AGENDA
DANIA BEACH CITY COMMISSION
REGULAR MEETING
TUESDAY, AUGUST 23, 2016 - 7:00 PM

A RESOLUTION OF THE CITY COMMISSION OF THE CITY OF DANIA BEACH, FLORIDA, APPROVING THE SITE PLAN (SP-75-15) AND DESIGN VARIATIONS (OT-64-16) AND (OT-82-16) SUBMITTED BY DAVID L. WALLACE & ASSOCIATES, INC. ON BEHALF OF THE OWNER, ALEXEY SHCHETNIKOV, FOR PROPERTY LOCATED AT 321 NORTH FEDERAL HIGHWAY IN THE CITY OF DANIA BEACH, FLORIDA; PROVIDING FOR CONFLICTS; FURTHER, PROVIDING FOR AN EFFECTIVE DATE.

1 BUILDING SECTION 2
A-301 1/8" = 1'-0"

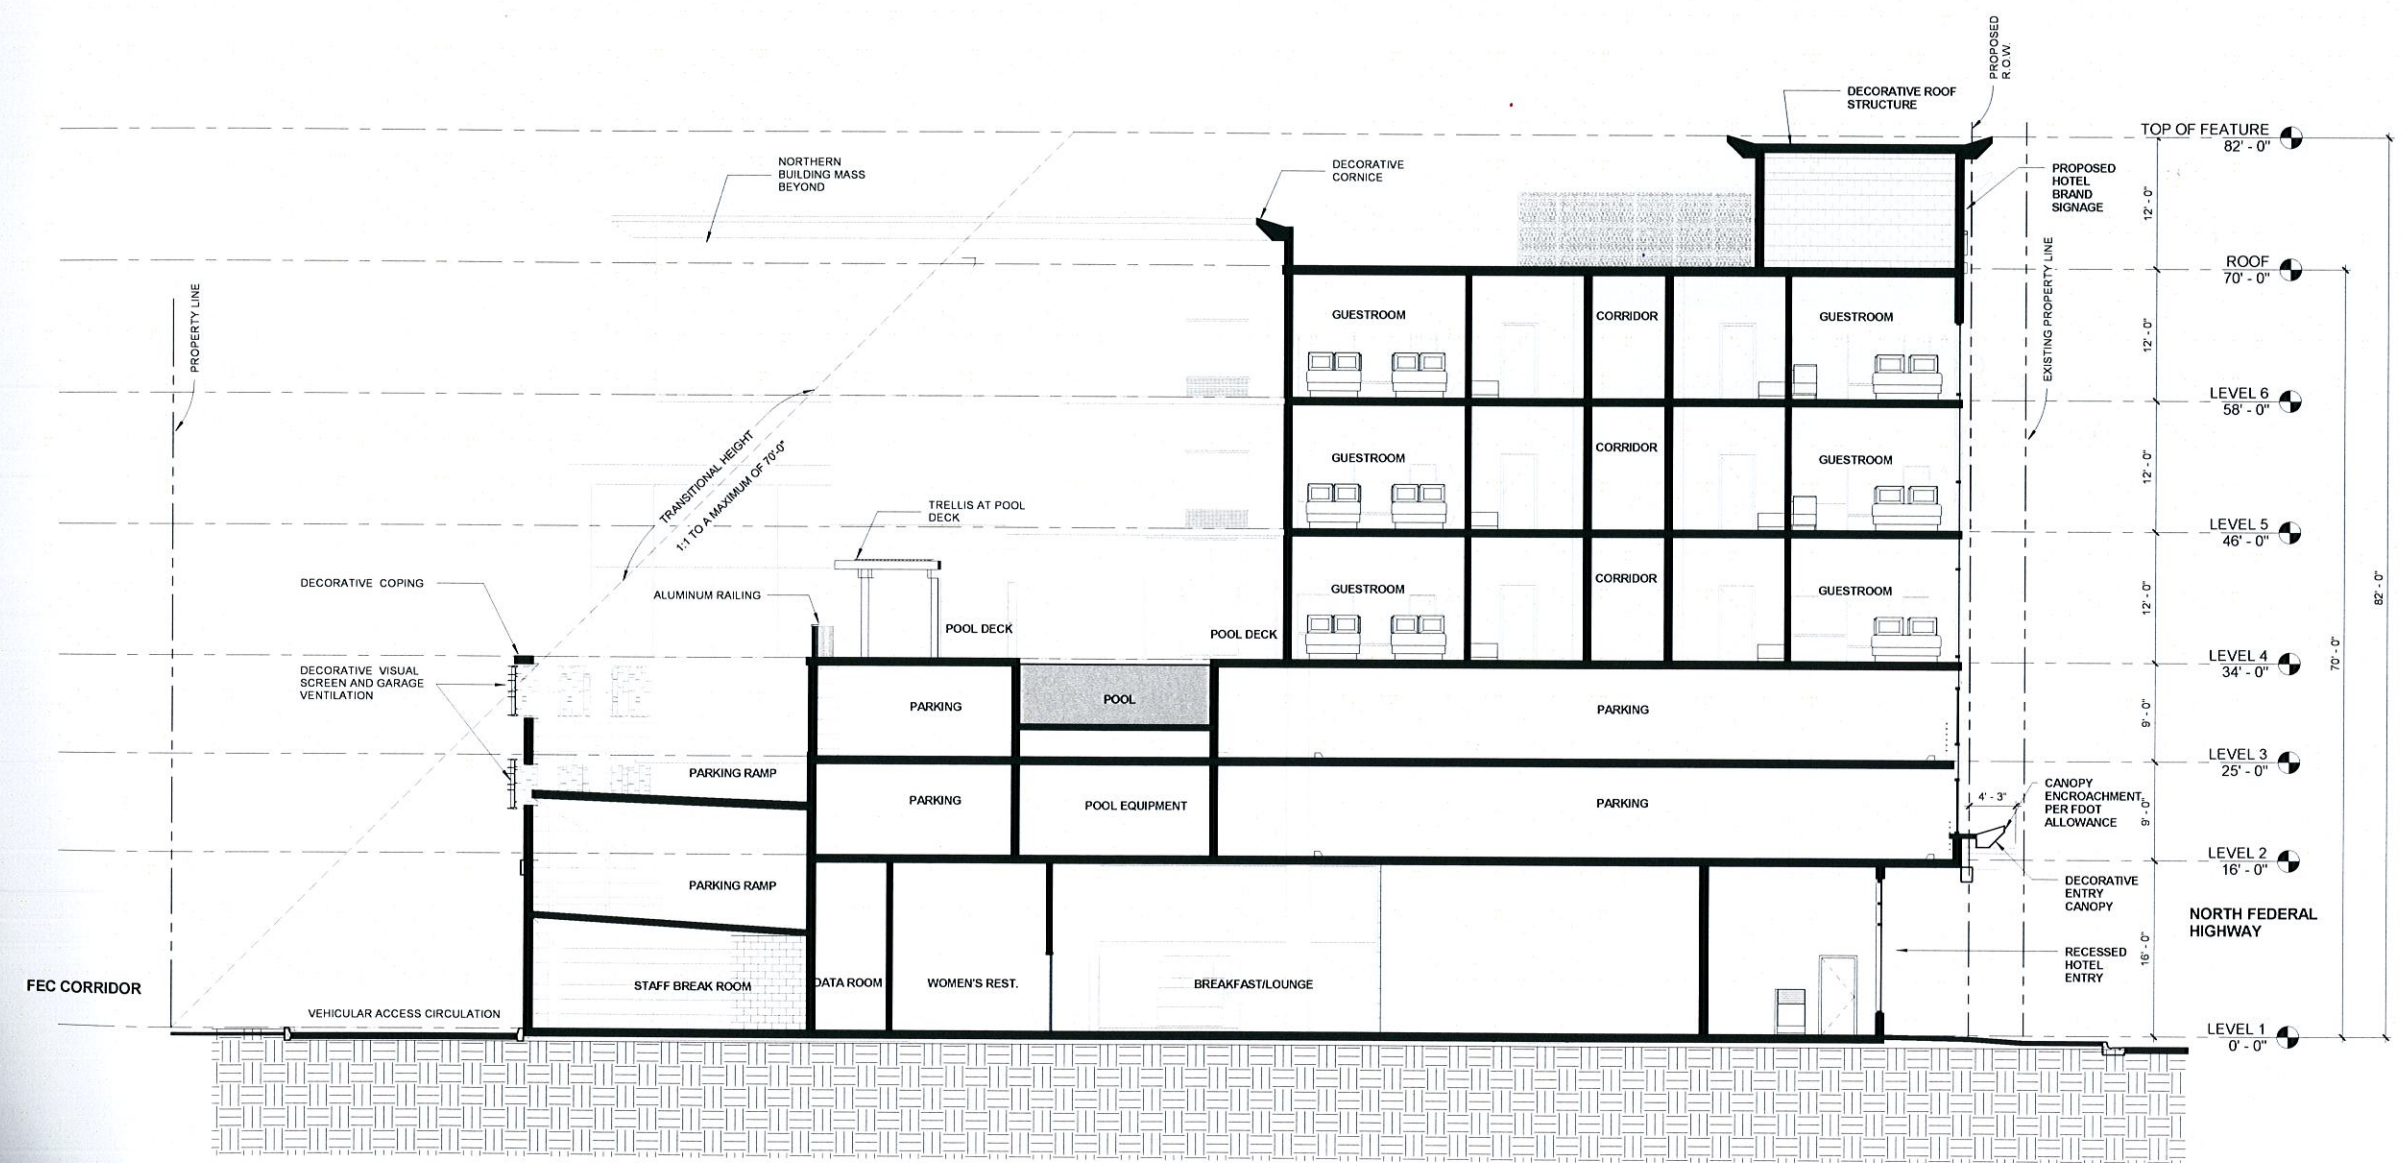
37. Per Section 303-40(Q), Figure 303-10 & 304-30 allowable height is based on proximity to residential and FEC railroad. Provide illustration showing building mass is outside of the 1.66:1 slope. Provide illustration with next submittal. Revise to reflect property slope. 2nd time requested (Planning).

RESPONSE: REFER TO SECTION DRAWING 1/A-301 AND AR-102 ILLUSTRATING BUILDING MASS REFLECTING THE DISCUSSIONS IN THE INITIAL ROUNDTABLE DISCUSSIONS MEETINGS WITH MARC LAFERRIER. APPROXIMATELY 1/3 OF THE BUILDING MASS COMPLIES WHILE THE REMAINING BALANCE SERVES TO FORM THE EXTERIOR COURTYARD WHOSE ARRANGEMENT AND PURPOSE IS TO REDUCE THE VISIBILITY AND EXPOSURE OF THE FEC CORRIDOR.
